WAIKANAЕ NORTH DEVELOPMENTS LIMITED

SECTION 53 COMMENTS LANDSCAPE ARCHITECTURE RESPONSE

Project	Waikanae North Development
Application reference	FTAA-2603-1194
Site	169-171 Peka Peka Road, Waikanae, Kāpiti Coast
Document	Response to comments received under section 53, Fast-track Approvals Act 2024
Prepared by	Local Landscape Architecture Collective Ltd
Date	7 August 2026
Status	Final

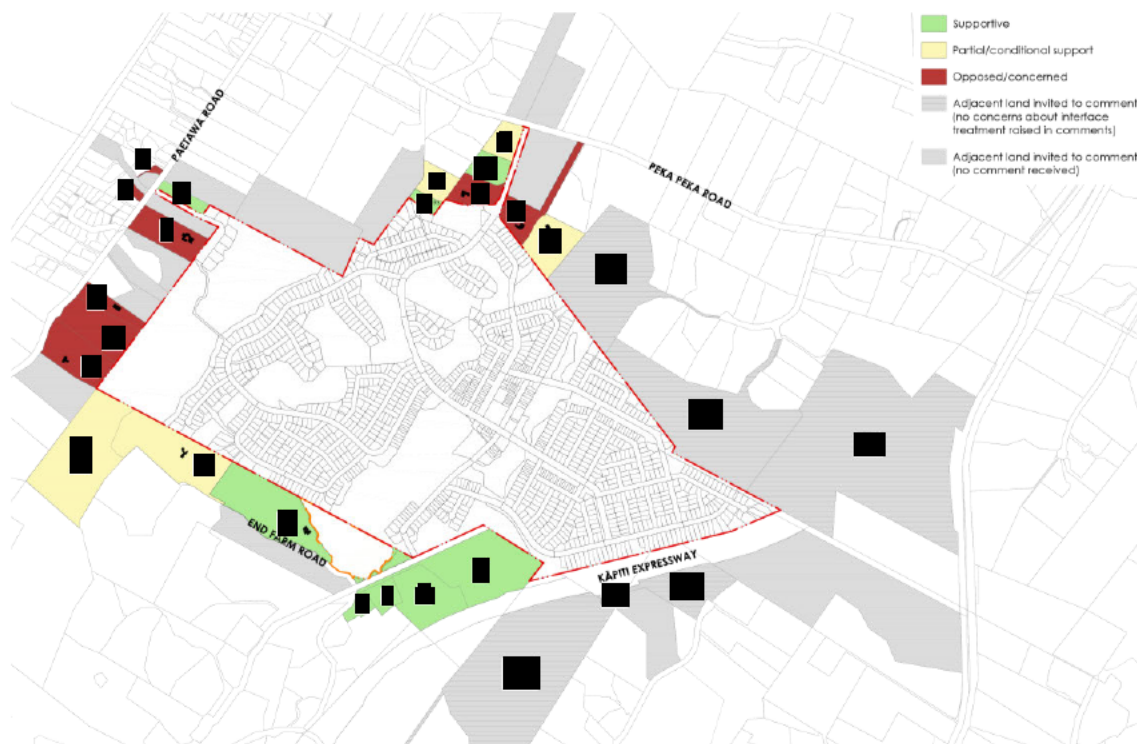
11.3 - The visual impacts are assessed in the SA as low to moderate to neighbours. This significantly understates the position, given the earthworks, landscaping, construction activities and final urban design densification is significant compared to the status quo. The current visual aesthetic is of grasslands, pastures, low, mid and tops of sand dunes. These elements will be replaced by roads, pavements, lighting, fences and residential dwellings. This represents a significant change in visual effect, which can only be adverse, both during the 10–15-year construction period and once completed – not a low to moderate change as contended by WND and its advisers.

16.3 - The visual impacts are significant rather than low or moderate and specifically where the development is proposed to build on sand dunes on the Western boundary adjacent the Te Harakeke wetland, building on these higher levels will have a significant and adverse effect on the visual outcome. The building Block planning report 3.4.1.2.1 also states “The rural character of the zone can be adversely affected by the presence of highly visible development and changes to dune landforms which cause disturbance to the natural contours and any significant cultural features of the area” It also states that “The overall density of development should be very low so as to retain the areas sense of openness”

The LVA acknowledges that development will result in a noticeable change from the existing pastoral, grassland and dune landscape and therefore assesses visual effects during construction as **moderate**. It is clearly acknowledged that the proposal being advanced is an urban development outcome. However, the assessment does not consider these effects to be significant due to the nature of the receiving environment and the mitigation measures proposed.

Once completed, visual effects of the development are assessed as reducing to **low-moderate**, with some positive effects arising from extensive restoration planting, wetland enhancement and increased indigenous vegetation cover.

In relation to development on higher dune landforms adjacent to Te Harakeke Wetland, the assessment specifically considered the visibility of proposed built form. Significant adverse visual effects were not identified due to a combination of mitigation measures, including careful lot placement and configuration, careful earthworks design, restrictions on building height, colour and materials, retention of the most prominent dune crests, and the establishment of screening vegetation (as indicated on LA9.00). For these reasons, the LVA and peer review conclude that the visual effects are appropriately characterised as moderate during construction and low to moderate in the longer term, rather than significant.

We have considered the submitter's concerns but maintain that the Landscape & Visual Assessment accurately characterises the anticipated visual effects of the proposal and that the proposed mitigation measures are sufficient to avoid significant adverse visual effects.

Aerial drone photograph from within the site facing east towards 155 Peka Peka Road (approximate site boundary shown red dashed).

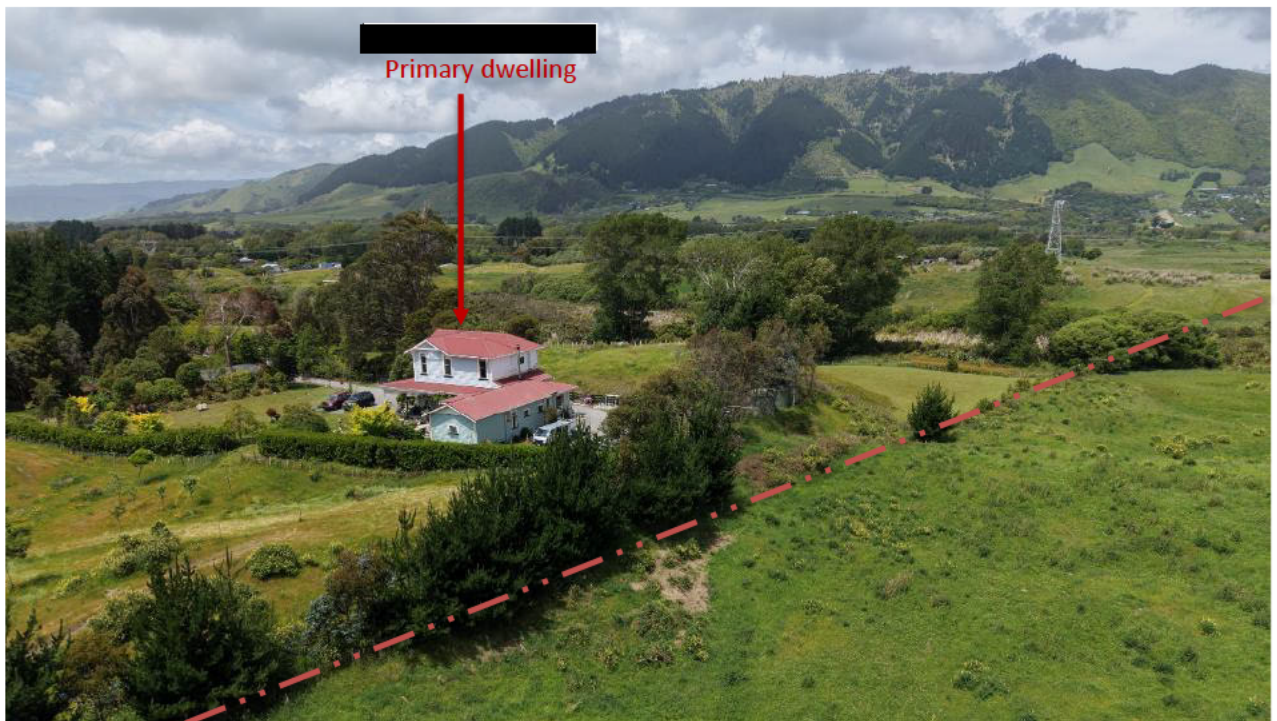
Comments: 17.1, 17.4, 17.7 | Commenters: 17 - Dean & Miriam Lewin

The LVA acknowledges that development of the site will introduce an urban form of development across a site that is currently rural in character. The assessment's conclusion regarding a transition from a predominantly rural character is based on the scale and nature of the proposed development itself, including the introduction of residential lots, roads, open spaces and associated infrastructure. However, the development has been designed to retain important elements of the existing landscape through extensive open space areas, wetland restoration, dune landform protection, rural-edge planting, and controls on building height, colours and materials in sensitive locations. Together, these measures are intended to manage the transition in character, reduce the visual effects of development, and maintain an appropriate interface with adjoining rural-residential properties.

The submitters' concerns regarding privacy, overlooking, visual dominance, street lighting and residential activity have been carefully considered in the design of the development and the mitigation measures. Lots adjoining rural-residential properties, including [REDACTED], will be subject to the External Boundary Treatment at the Rural Interface (refer LA9.00), incorporating mitigation planting and minimum building setbacks, reflective of those in place for the Rural Zone. The primary dwelling at [REDACTED] is elevated above, and oriented away from, the development site, and benefits from existing vegetation along the boundary. This configuration, together with the proposed boundary planting, building height restrictions, low-reflectivity building materials, will reduce the visibility and perceived dominance of the development. As the proposed vegetation establishes and matures, it will further filter views of residential activity and street lighting. Consequently, there will be no significant adverse effects on the dwelling at [REDACTED], no unreasonable intrusion on privacy, and no visual dominance.

The landscape buffers recommended in the LVA have been peer reviewed and are considered sufficient to provide an appropriate transition between the proposed development and adjoining rural-residential properties.

While the LVA did not identify the need for reduced building heights further in this location, as part of this response to section 53 comments, the applicant proposes that Lots 944, 945 and 955-963 be subject to a maximum building height of 4.5 metres. This proposed reduction in height at this location will provide a lower-scale built form along this portion of the site adjoining [REDACTED]. In our opinion, the effect on the adjoining property along this interface will be no more than minor.

Updated drawing LA9.00 and conditions of consent to secure this matter.

Aerial drone photograph from within the site facing east-southeast towards [REDACTED] (approximate site boundary shown red dashed).

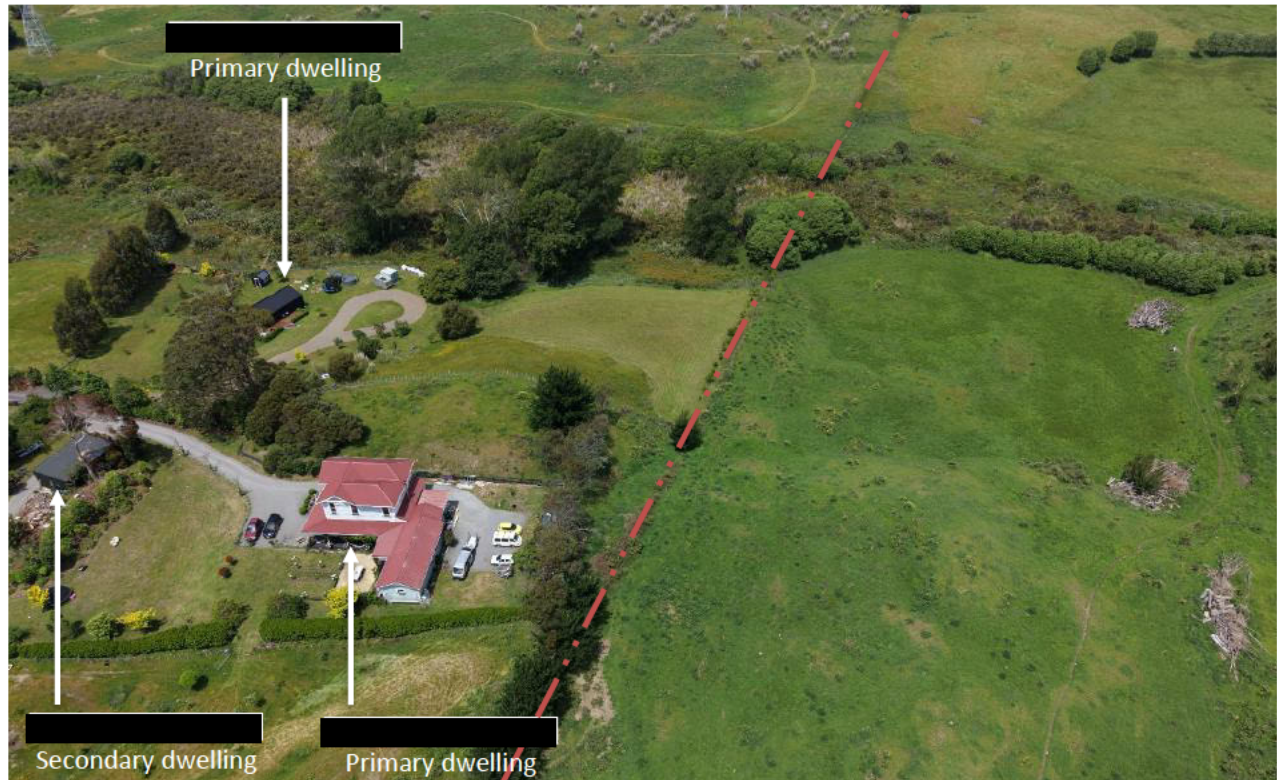
Planning documents acknowledge that [REDACTED] has an unrestricted close-range view from the rear of the property into the development site.

12.6 - We have concerns about statements within the planning documentation that suggest the rural lifestyle character of the area will naturally transition to a more residential environment over time.

"At the entrance to the site a cluster of rural residential properties () bound the site access from Peka Peka Road. The nature of Peka Peka Road is currently rural lifestyle, however due to its proximity to the Peka Peka Link Road /Main Road to Waikanae and other rural residential activity in close proximity, it is anticipated that this character will change to a more residential nature over time."

We consider this statement to be an assumption rather than a demonstrated or evidence-based conclusion. They are concerned that it appears to imply neighbouring rural lifestyle property owners should accept a future change in character without sufficient supporting analysis.

The submitters' concerns regarding outlook, privacy and the retention of a rural interface have been carefully considered in the design of the development and the mitigation measures proposed. While the LVA did not identify the need for all dwellings adjoining to be limited to a single storey, we confirm that as part of this section 53 comments response this request has been incorporated into the proposed design response.

Lots adjoining this boundary will be subject to the External Boundary Treatment at the Rural Interface (refer LA9.00), including mitigation planting, and will also be required to maintain a minimum 5 metre setback from the boundary. In addition, we propose that Lots 944, 945 and 955-963 be subject to a maximum building height of 4.5 m, providing a lower-scale built form along this portion of the site boundary and reducing the visibility of future development from adjoining properties.

The dwelling at is set back approximately 100 m from the site boundary and oriented with its outdoor living area on the northwestern side of the dwelling. There is a substantial amount of established vegetation between the dwelling and development site with evidence of new planting along the boundary parallel to the proposed mitigation planting on the development site.

In regard to rural character, the proposal will introduce a more residential form of development across a site that is currently rural in appearance. The LVA's conclusion on the transition from a predominantly rural character is based on the scale and nature of the proposed development itself, including the introduction of residential lots, roads, open spaces and associated infrastructure. However, the development has been designed to retain important elements of the existing landscape through extensive open space areas, wetland restoration, dune landform protection, rural-edge planting, and controls on building height, colours and materials along sensitive boundaries. Together, these measures are intended to manage the transition in character, soften views of development, and maintain an appropriate interface with adjoining rural-residential properties.

Aerial drone photograph from within the site facing north-northeast towards the site entrance (approximate site boundary shown red dashed).

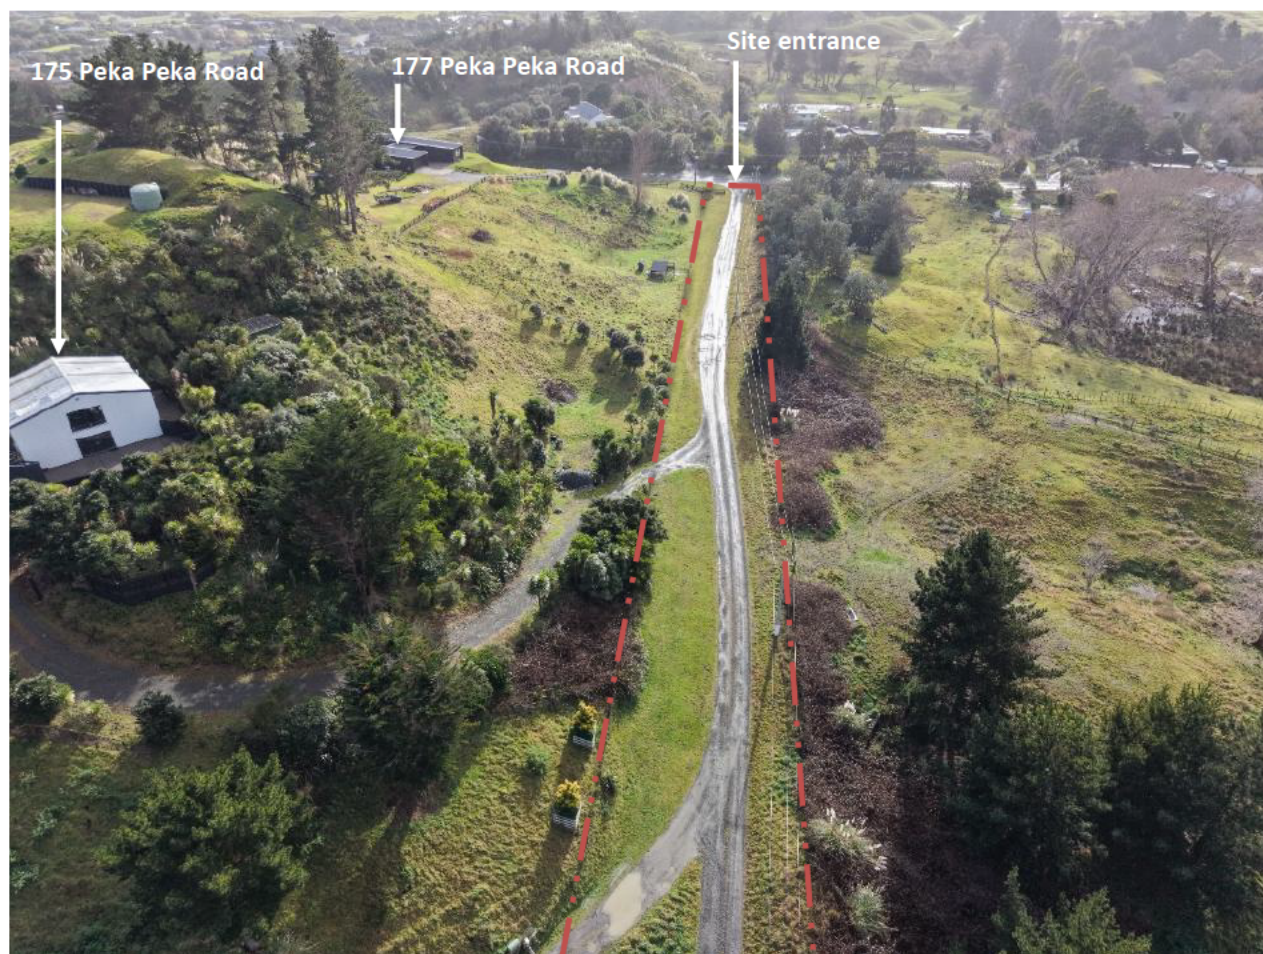
- new boundary fencing between the public road and adjoining private properties;
- consultation with affected landowners, being us at [REDACTED], and our neighbour at [REDACTED] regarding boundary fencing design, height, materials and location;
- early establishment of landscape planting;

- *evergreen screening to maintain privacy;*
- *replacement of any failed planting during the maintenance period.*

The proposed development includes specific fencing and landscape planting requirements along the rural boundaries to provide visual screening, maintain rural character, and manage the interface between the development and adjoining properties.

The proposed mitigation planting provides visual screening for adjoining properties assessed as requiring greater privacy and outlook protection. The recommended conditions also require replacement of failed planting to ensure the long-term effectiveness of the screening.

- We confirm that the existing boundary fence at [REDACTED] will remain unchanged, as shown on Drawing LA3.02. In addition, depending on the pet management approach chosen, a supplementary pet-control fence may be installed on the development side of the mitigation planting area. If it is to be installed, the location and design details of this fence are shown on Drawing LA3.02, with a typical example provided on Drawing LA3.03. This additional fencing would not disturb the existing fence along [REDACTED].

- [REDACTED] adjoin the proposed access road into the development, with the dwellings situated approximately 22 and 13 m above the accessway, respectively. Due to their elevated position, boundary fencing and planting along the accessway would provide limited visual mitigation, as it would not substantially screen views from or of the dwellings, which we note are orientated towards the coast and already limited. The proposed tree planting along the accessway is expected to provide effective and appropriate visual mitigation over time by softening views of the road, screening vehicle movements, and helping to define the interface between the development and adjoining properties. The proposed landscape treatment will result in a well-structured avenue that reinforces the character of the access road and provides an appropriate level of spatial definition. As such, the installation of a new boundary fence to replace the existing fencing is not considered necessary, nor would it materially improve the resulting landscape, visual, or amenity outcomes.

Extract from Drawing SK260729 - Adjacent Landowners Comments Received with overlay highlighting lots and the associated northern and southern boundaries noted by KCDC.

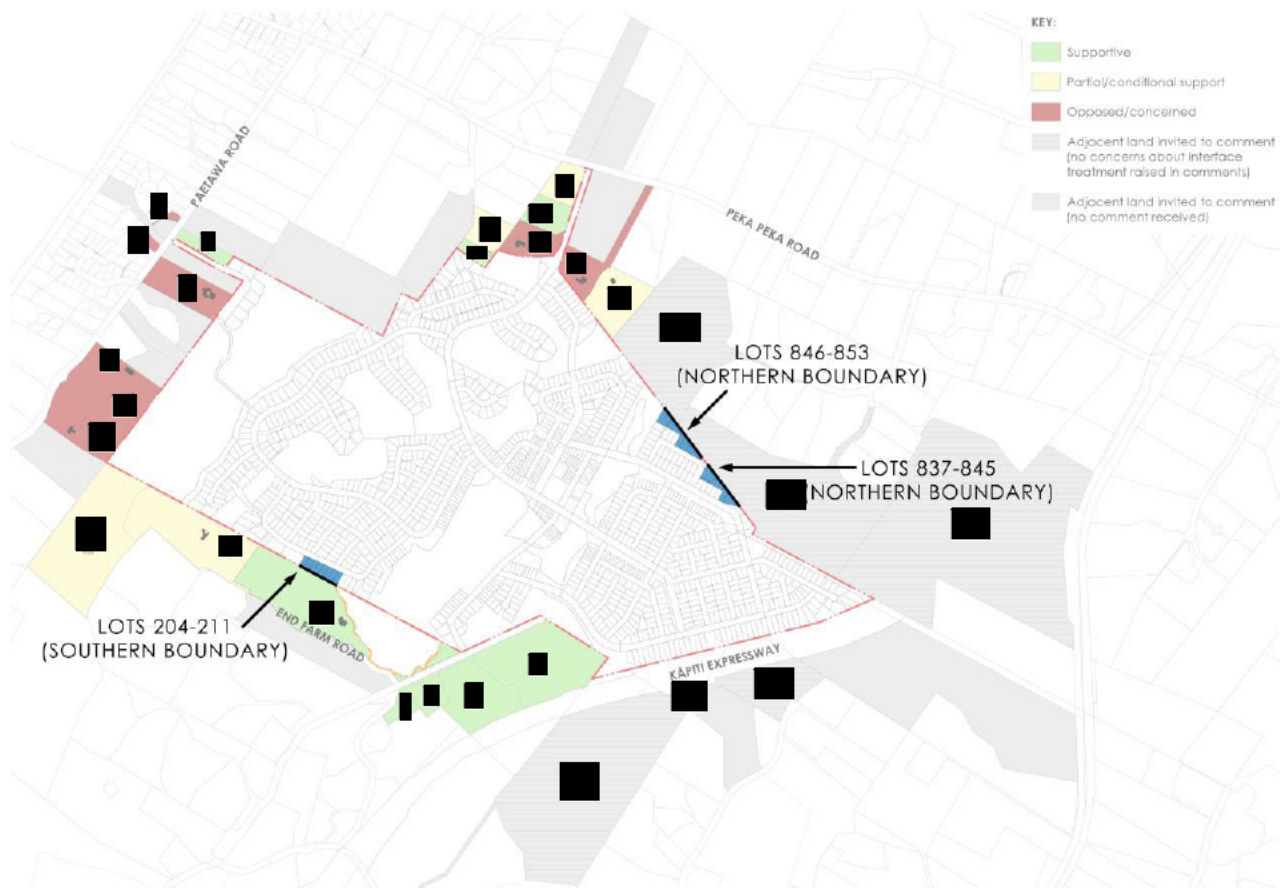
21.15 - *Further consideration is still required as to whether design-led interface measures, such as setbacks, density reduction or transition lots, are needed at the most sensitive residential/rural lifestyle boundaries.*

21.22 - *Increasing the lot size of boundary lots (proposed lots 837 to 845 and 846 to 853 along the northern boundary and lots 204-211 in the vicinity of End Farm Road on the southern boundary) to provide a clearer and more appropriate transition between adjacent rural properties and the boundary lots on the Site.*

17.6 - *Whether the proposed landscape planting and setbacks are sufficient to mitigate these significant effects.*

18.1 - *The proposed development will introduce multiple residential dwellings along our northern boundary which is a significant departure away from the permitted baseline. This level of development also represents a significant departure away from the values which drew us to our property and significantly impact on our future enjoyment of the property. To us, these represent unmitigated effects on our amenity, privacy and quiet enjoyment as a result of this project if it were to progress.*

The proposal has already been refined in response to landscape and urban design concerns relating to the residential-rural interface. As set out in the landscape memorandum dated 15 July 2026 (sent to KCDC and attached), the layout was revised following the pre-application peer review to reduce the number and linearity of residential lots adjoining northern boundaries. In addition, substantial open

In relation to the northern boundary, it is noted that the adjoining rural land does not form part of a wider contiguous rural landscape, but instead comprises an isolated pocket of rural land surrounded by the site and existing rural-residential development. The owner of this land (NZTA submission 28) has not raised any concern about the proposed development along this interface in its comment. Notwithstanding this context, the proposal incorporates a combination of setback controls, landscape buffering, open space areas and building controls intended to provide an appropriate transition between the proposed residential development and adjoining rural-residential properties.

Following feedback from the owners of [REDACTED], and as an additional interface mitigation measure, the applicant proposes amended controls applying to Lots 944, 945 and 955-963. As shown on amended Drawing LA9.00, these lots will be subject to a maximum building height of 4.5 m. While the LVA did not identify a need for reduced building heights in this area, this additional control provides a lower-scale built form at the development edge, further reducing visibility, perceived dominance and potential overlooking effects.

In relation to the southern boundary, the proposal incorporates setback controls, landscape mitigation planting and building controls along the southern boundary to provide an appropriate transition between the proposed development and adjoining rural-residential properties. It is also noted that the owners of [REDACTED] have submitted in support of the proposal (Submission 22). This leaves

Overall, it is considered that the combination of increased interface planting, boundary setbacks, open space areas, wetland corridors, retained vegetation, lot layout and additional building height controls provides an appropriate and proportionate response to the sensitivity of the residential-rural interface. As such, no further density reduction or increase in lot sizes is considered necessary to achieve acceptable landscape and visual outcomes.
